RE: Lot 25 Block 6 Volcano Cliffs Unit 18 SAD 228 6519 Pato Rd. NW Grading and Drainage Plan Engineers Stamp Date 9/9/19 (D10D003M25) Pad Certification Date 10/8/19

RE: Hydrology File # D10D003M25 - 6519 Pato Rd. NW - Pad Certification

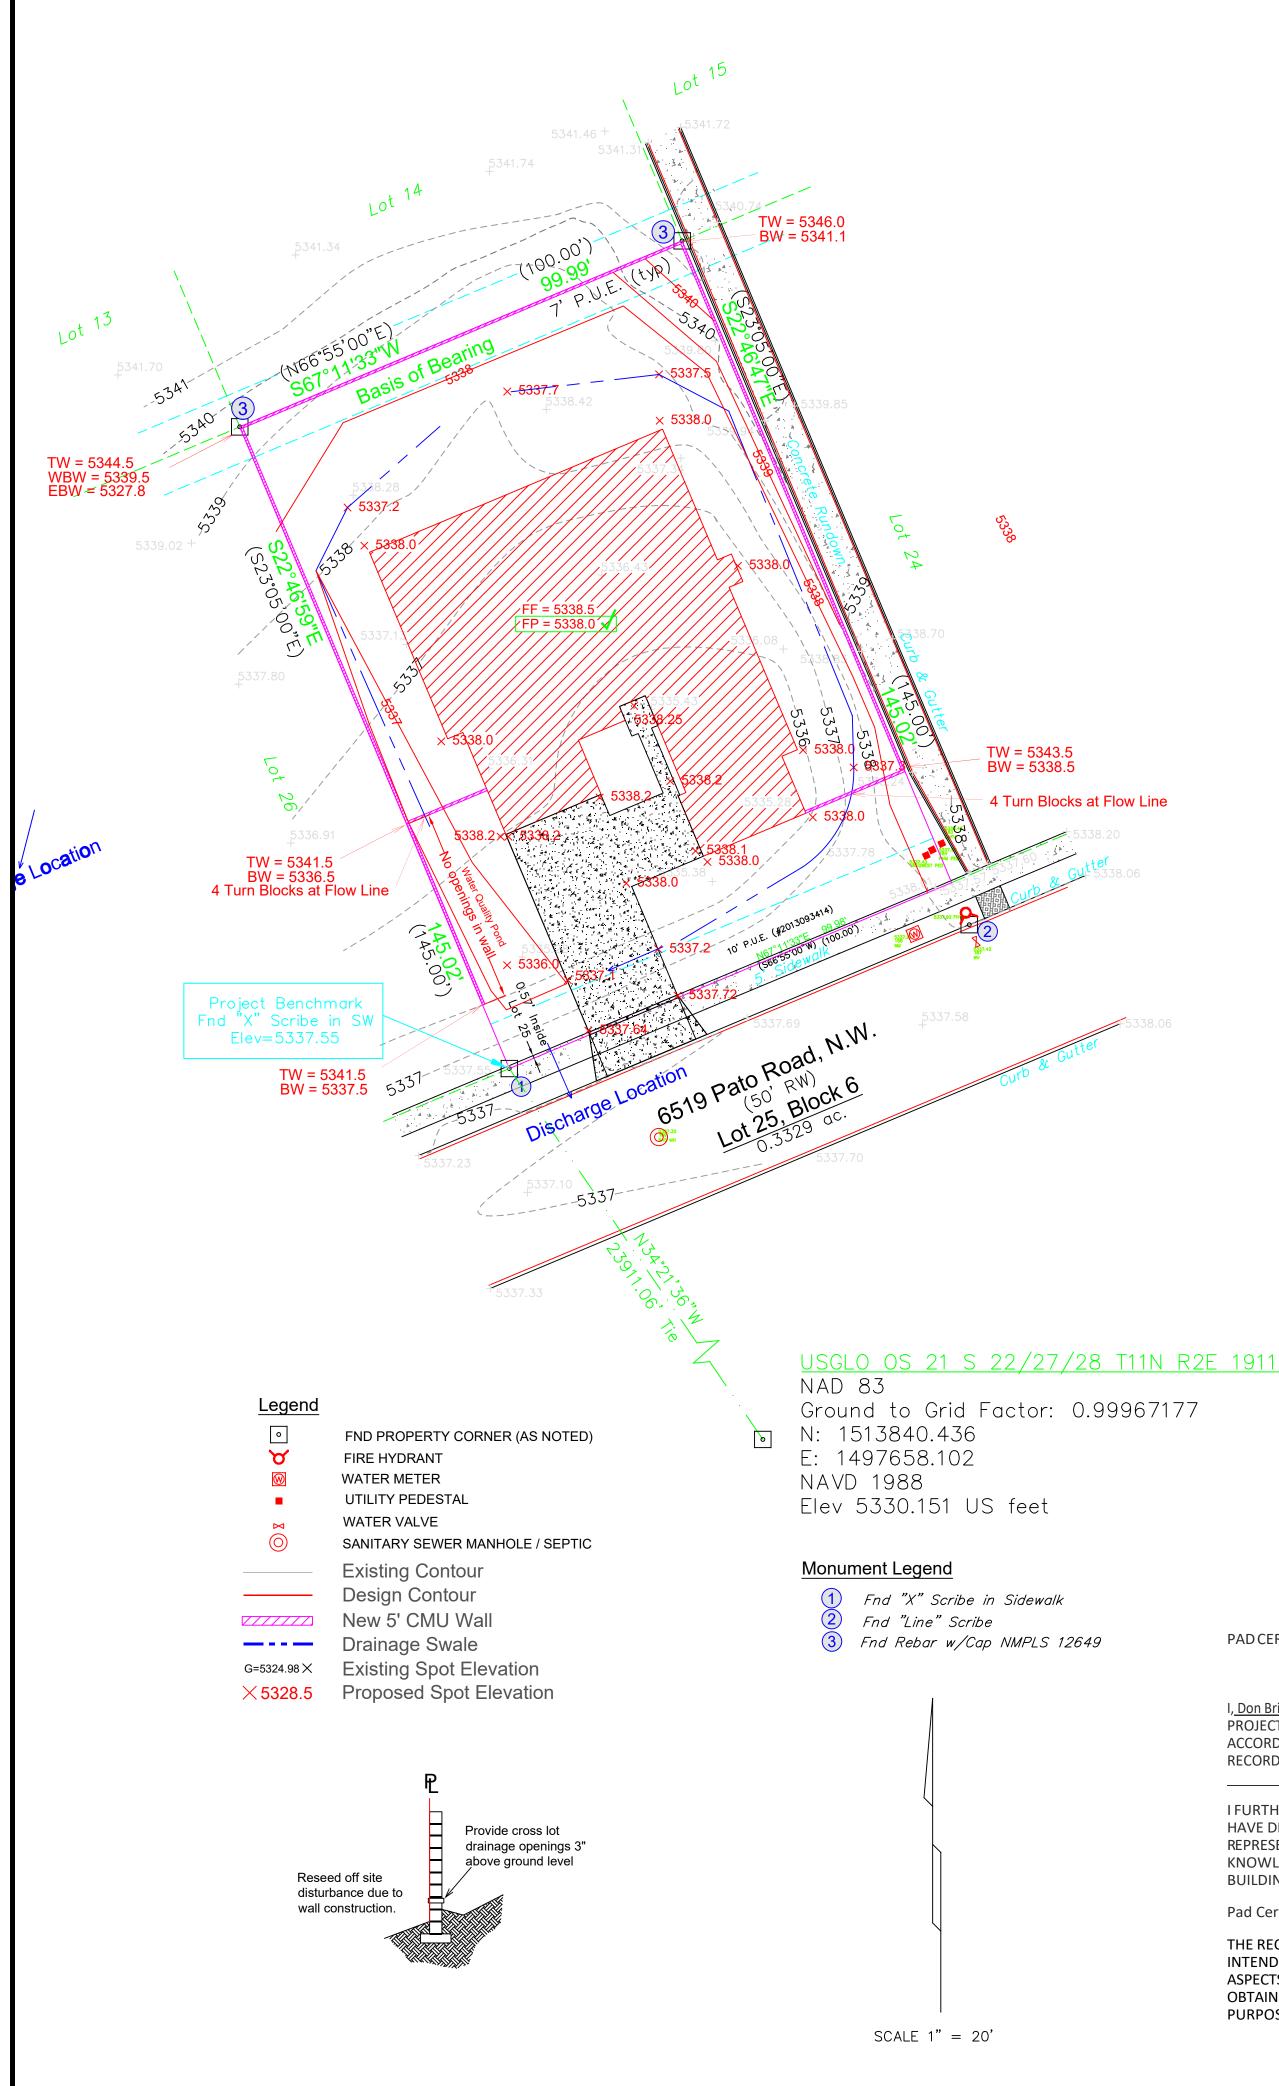
Attached are photos addressing your comments of October 11, 2019. They indicate that the dirt located in the roadway and on the sidewalk has been removed.
